## Contract Routing Form

Project: State St Reconstruction Assessment District-2014

Contract No.: 7206  
Enactment No.: RES-14-00333  
Dollar Amount: 4,733,488.80

1 CIRCULAR SEATING NODE PLAN ENLARGEMENT  
S-21 1/2"=1'-0"

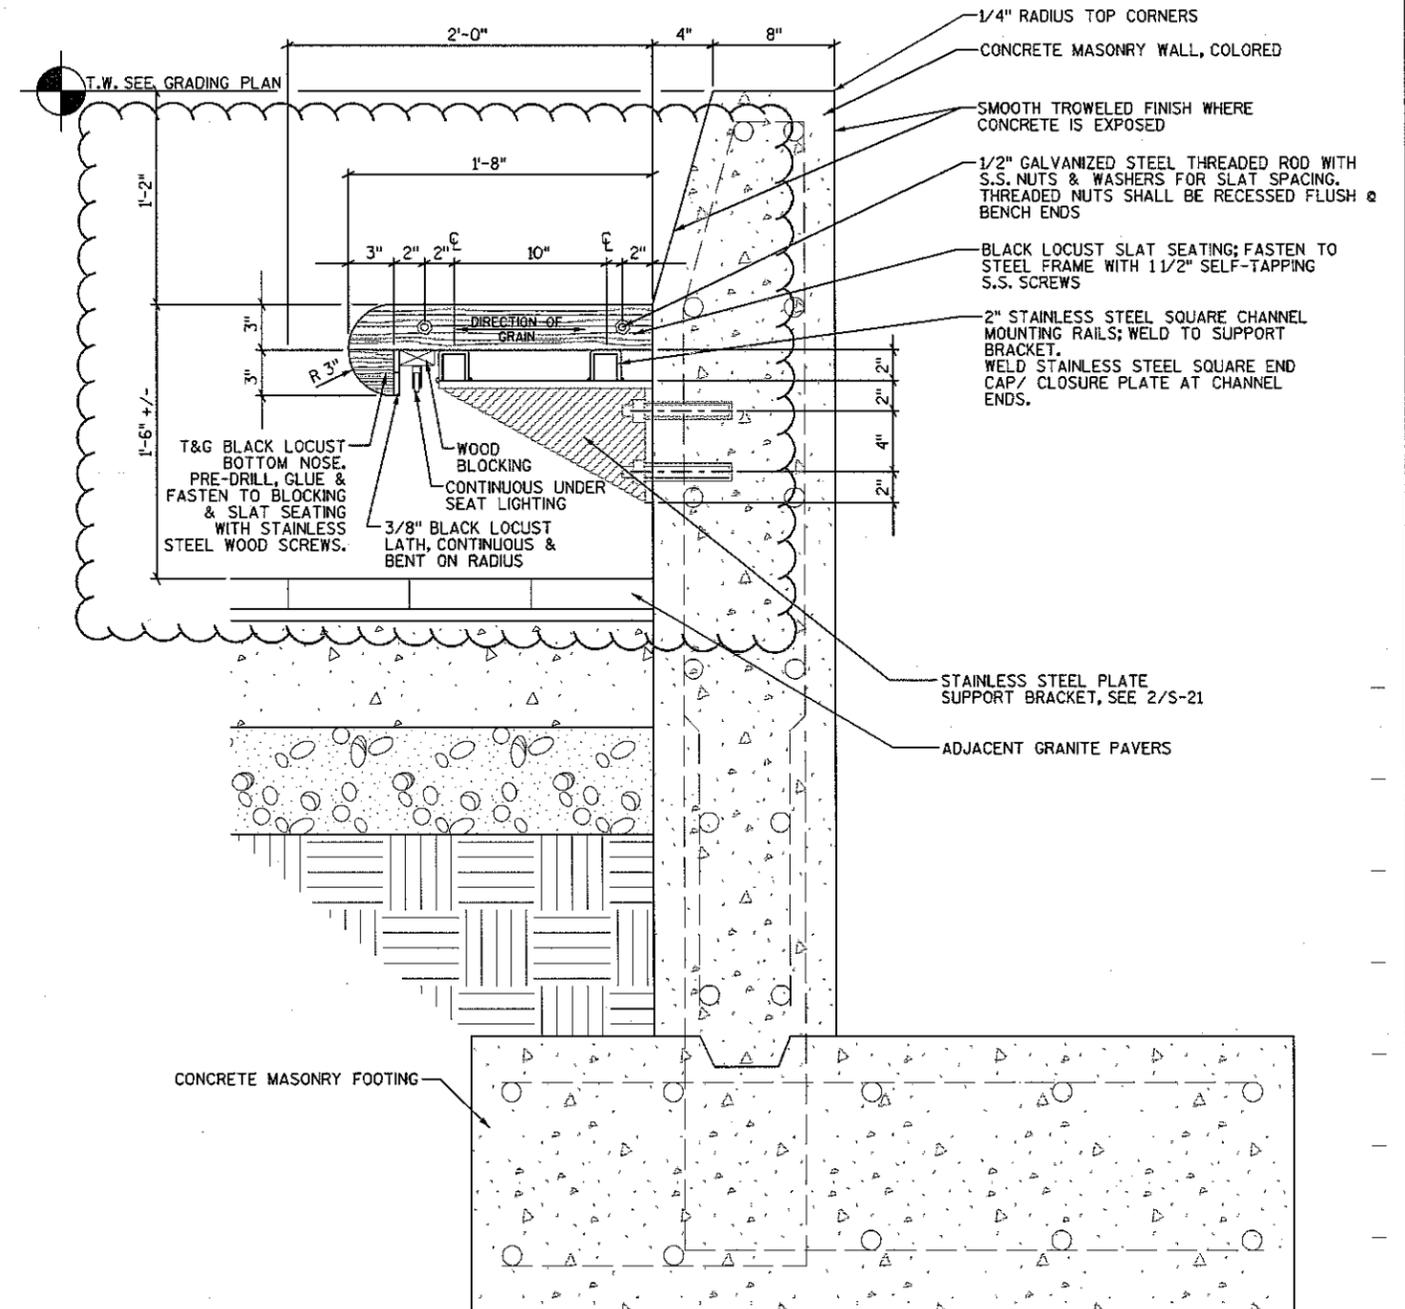
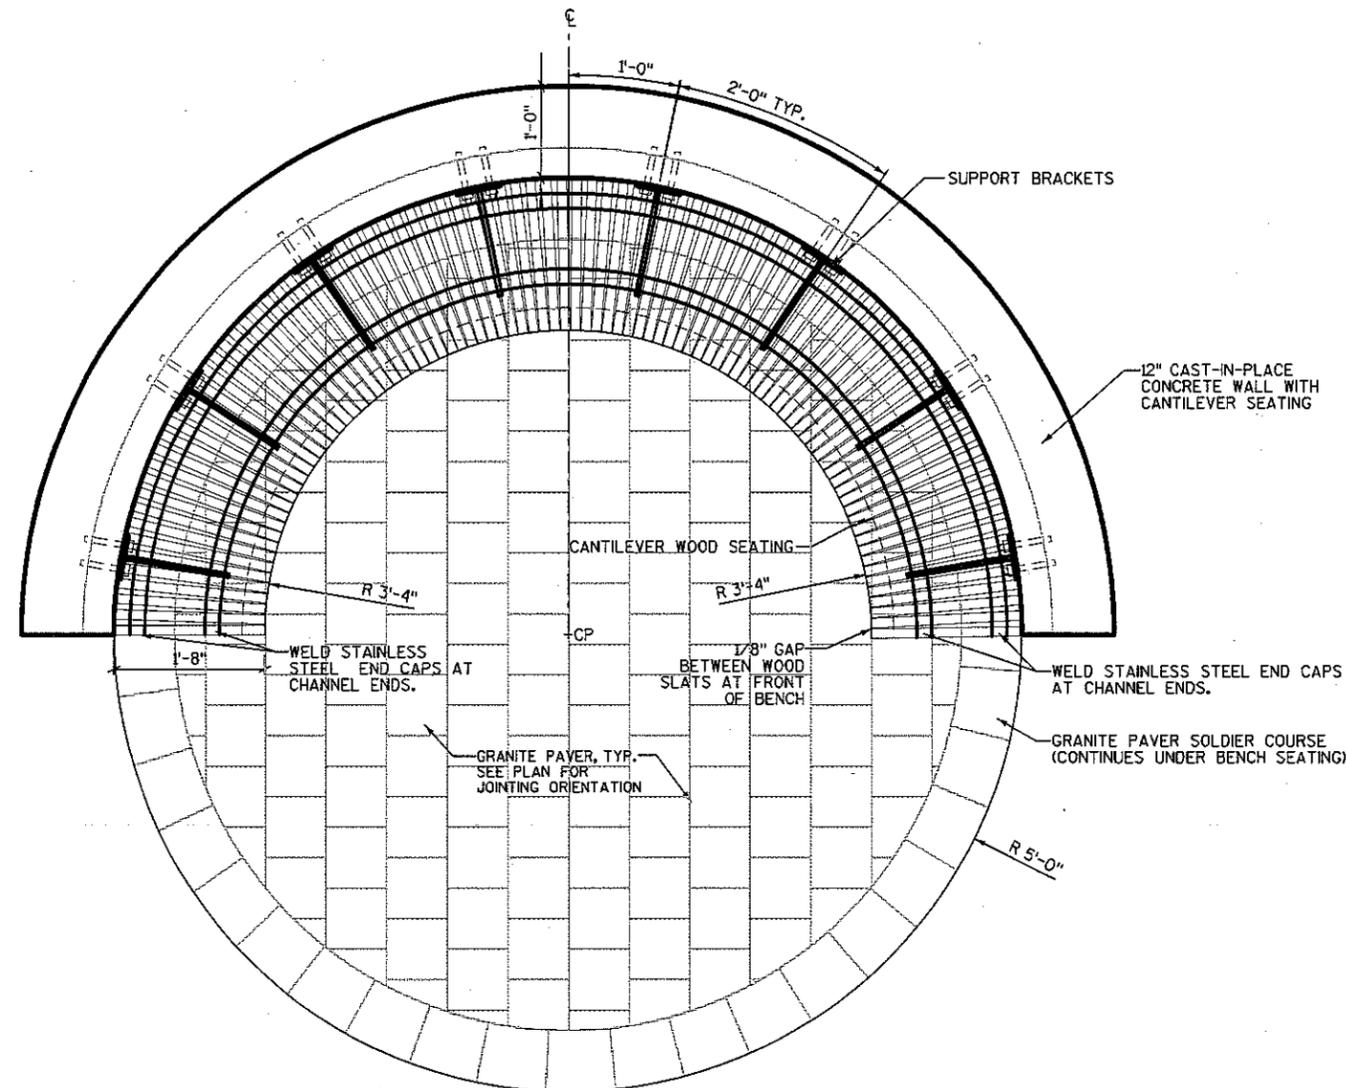
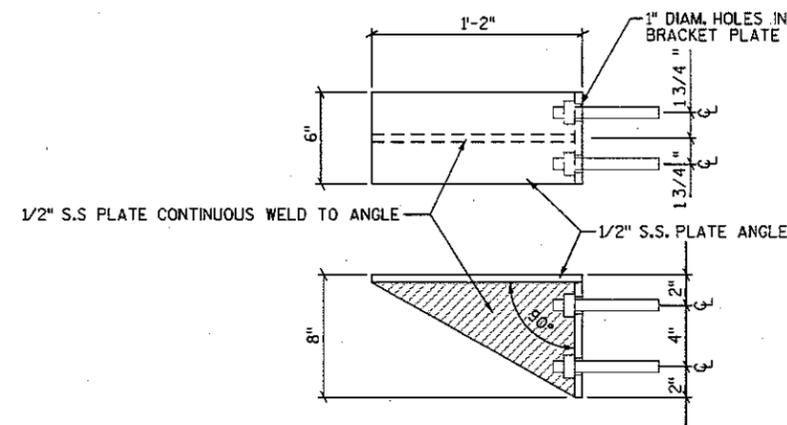
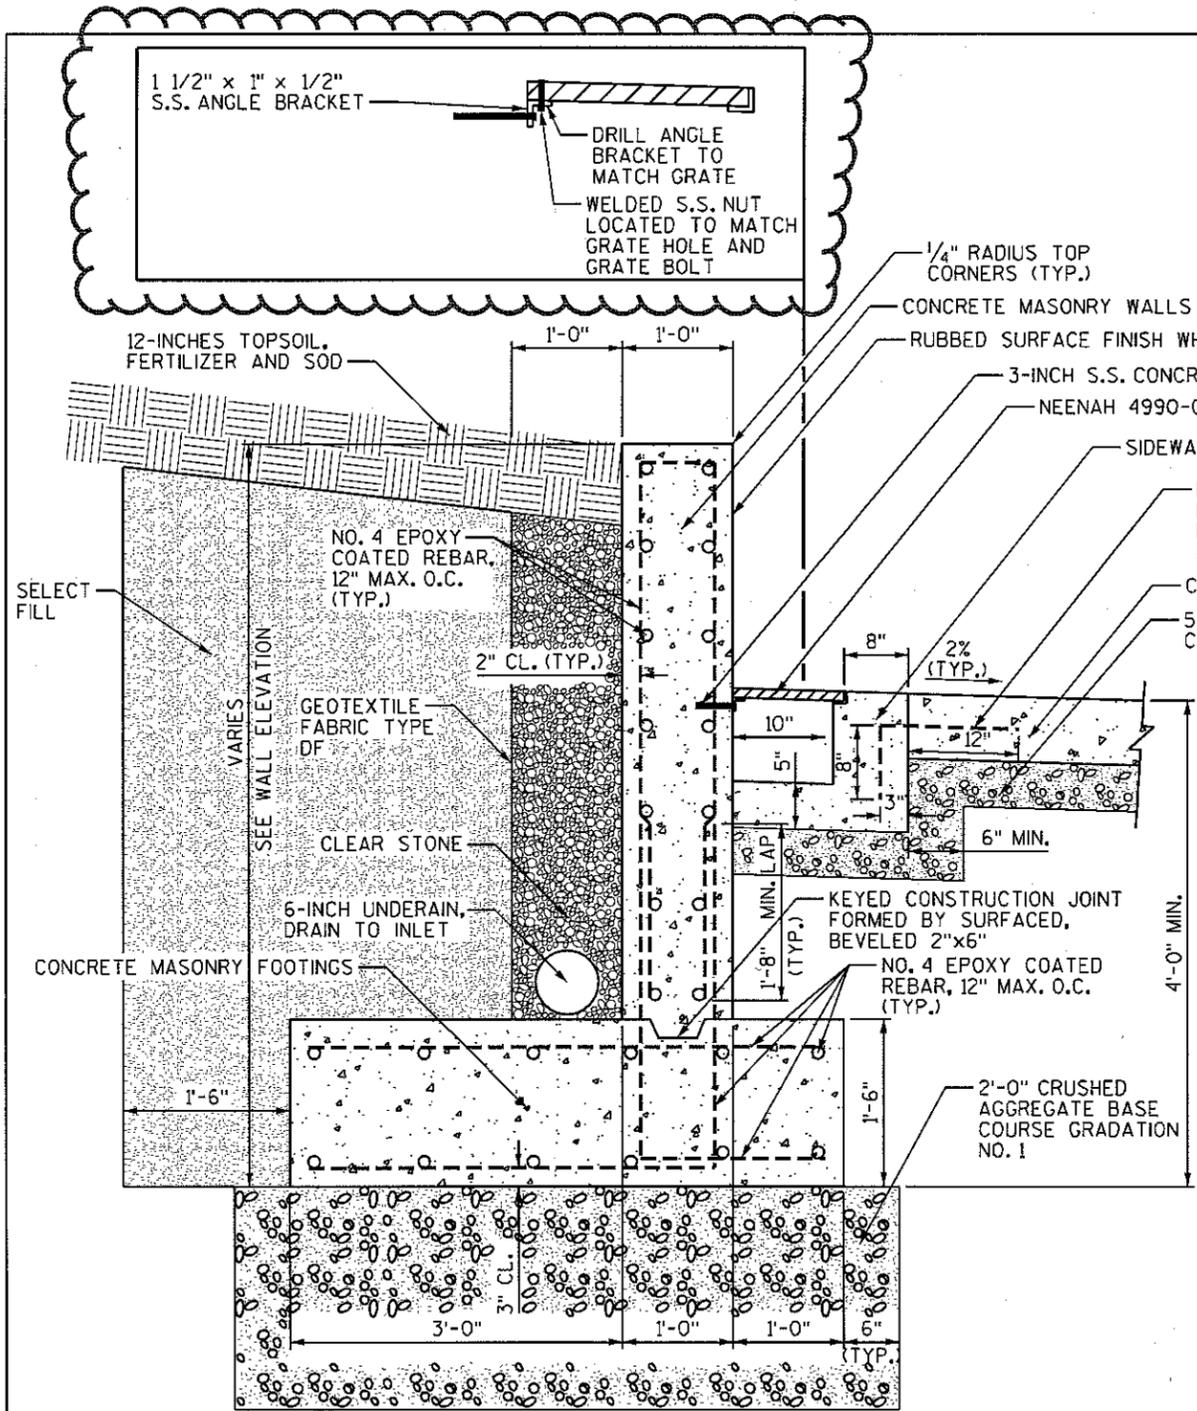
Replace Sheet S21 (Revised 3/20/14) – Modified detail for wood cantilever seating.

Revised 3/20/14 - Modified detail for bottom rail of wood seat.

REVISED 3/21/14: Added angle bracket detail for installing angle bracket to CIP concrete wall

1 CAST-IN-PLACE CONCRETE RETAINING WALL @ BASCOM MALL  
S11 SCALE: NONE

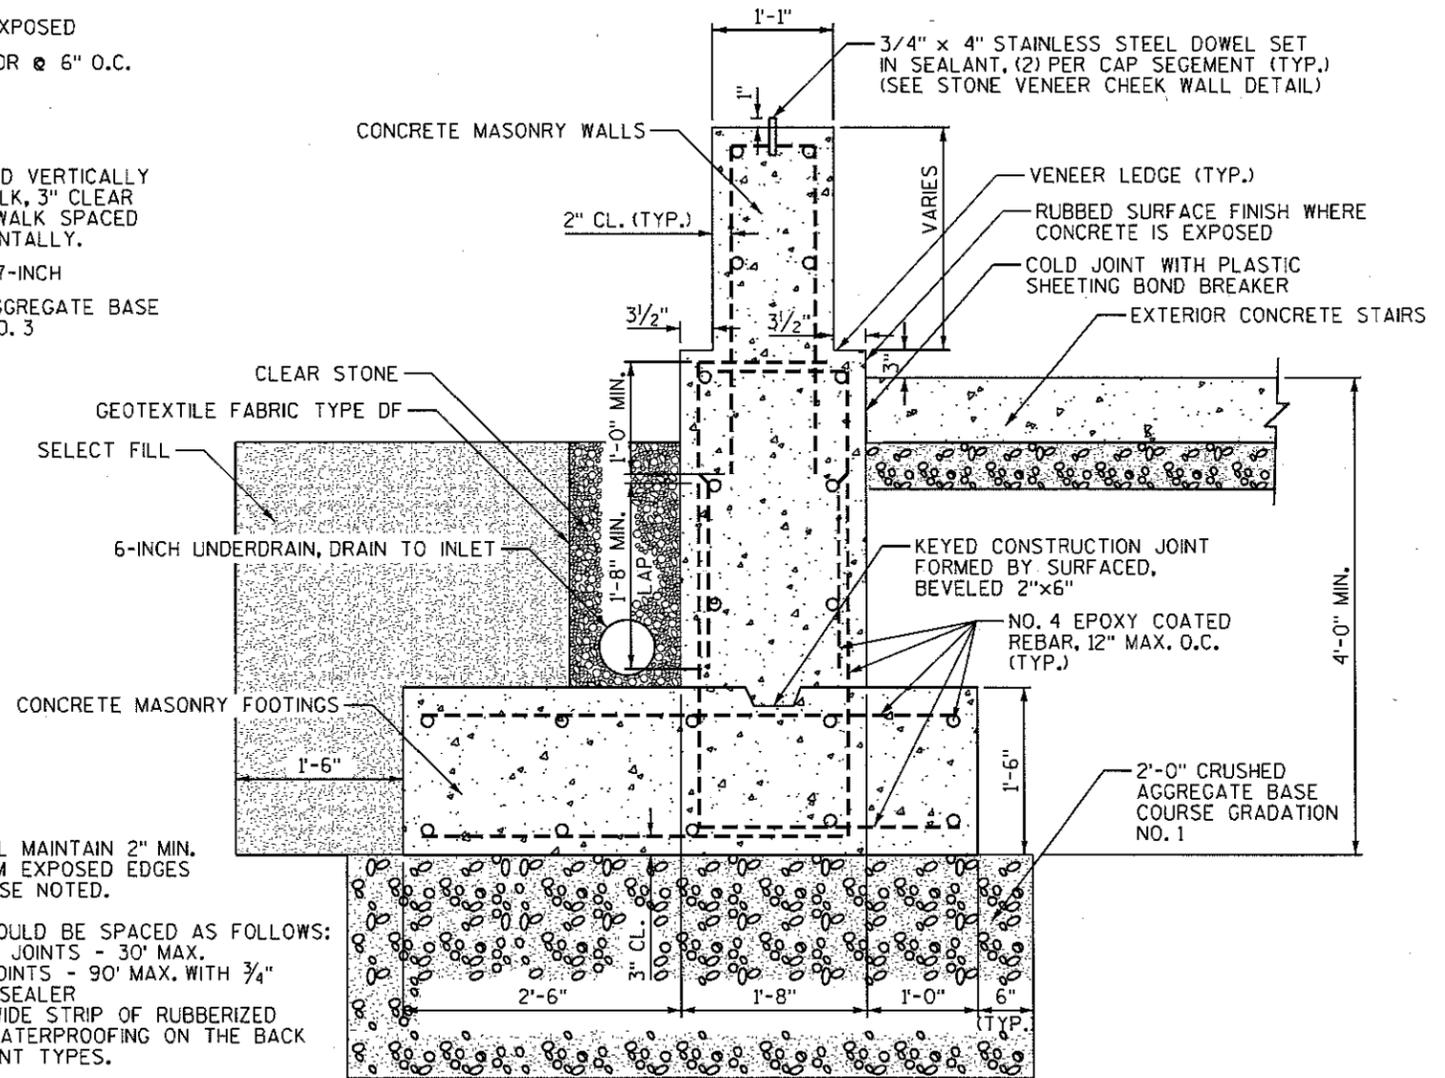
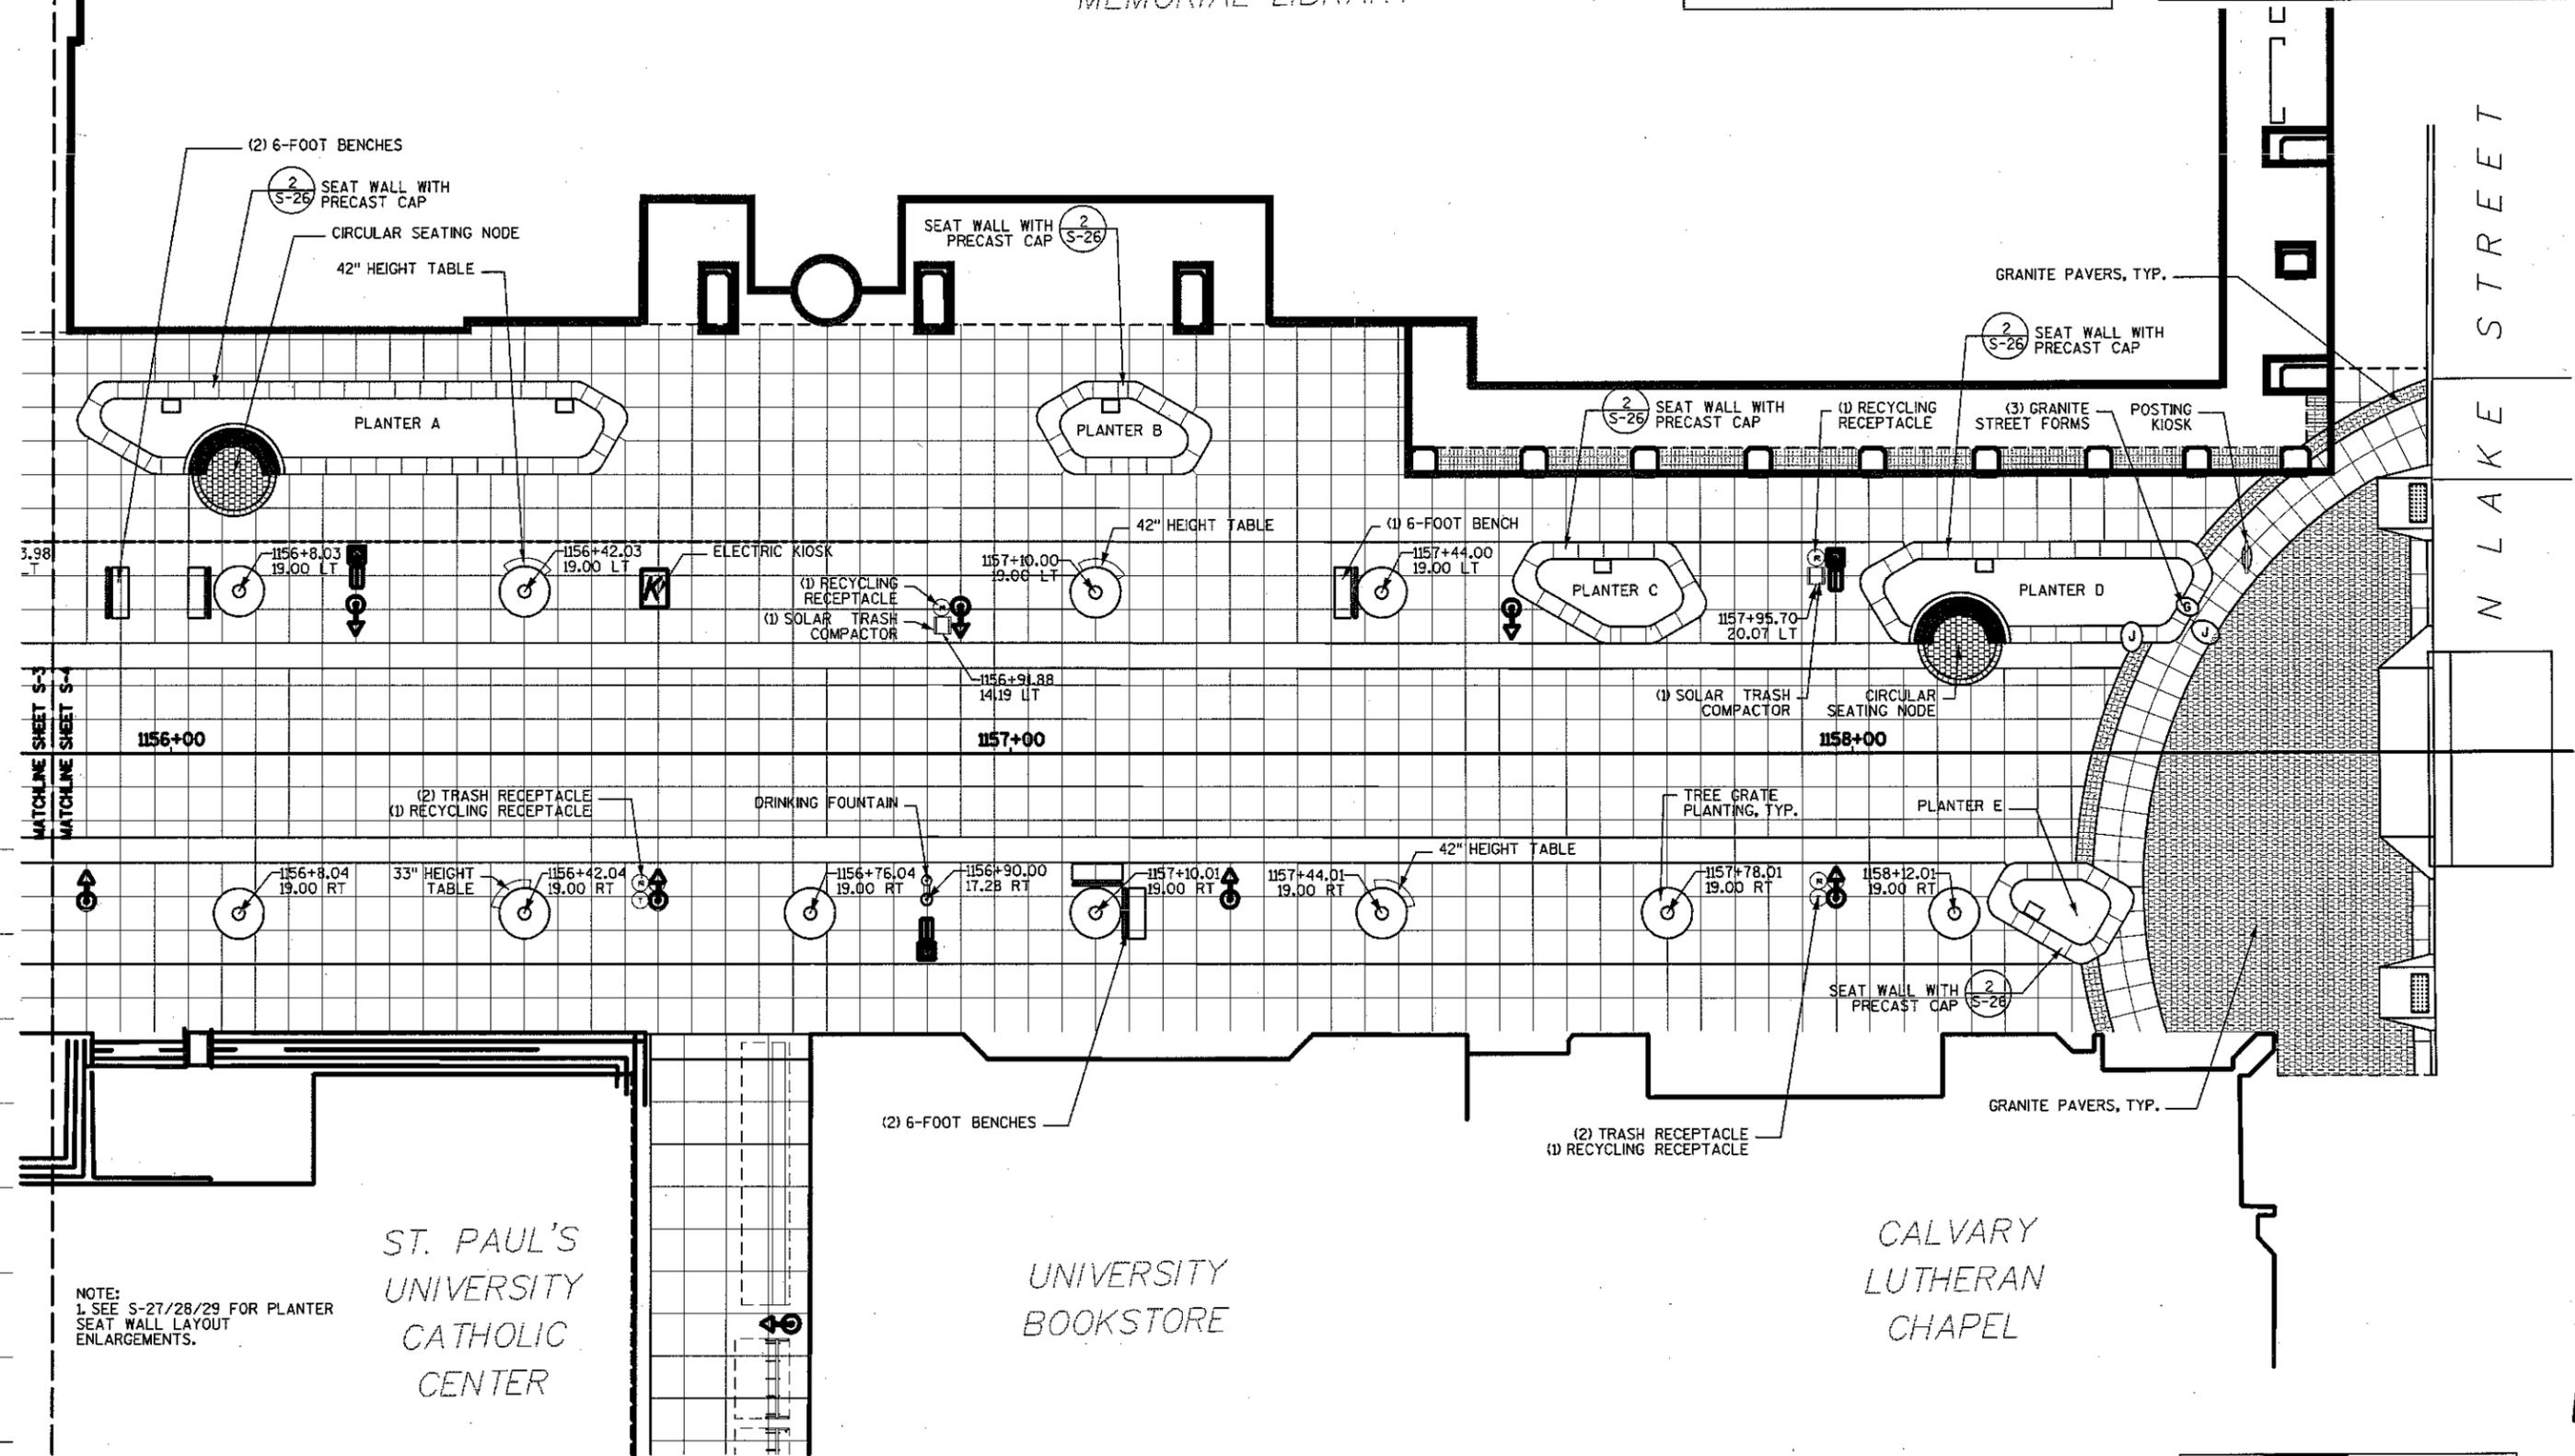
Replace Sheet S11 (Revised 3/21/14) – Added detail for the Sidewalk Drain installation.
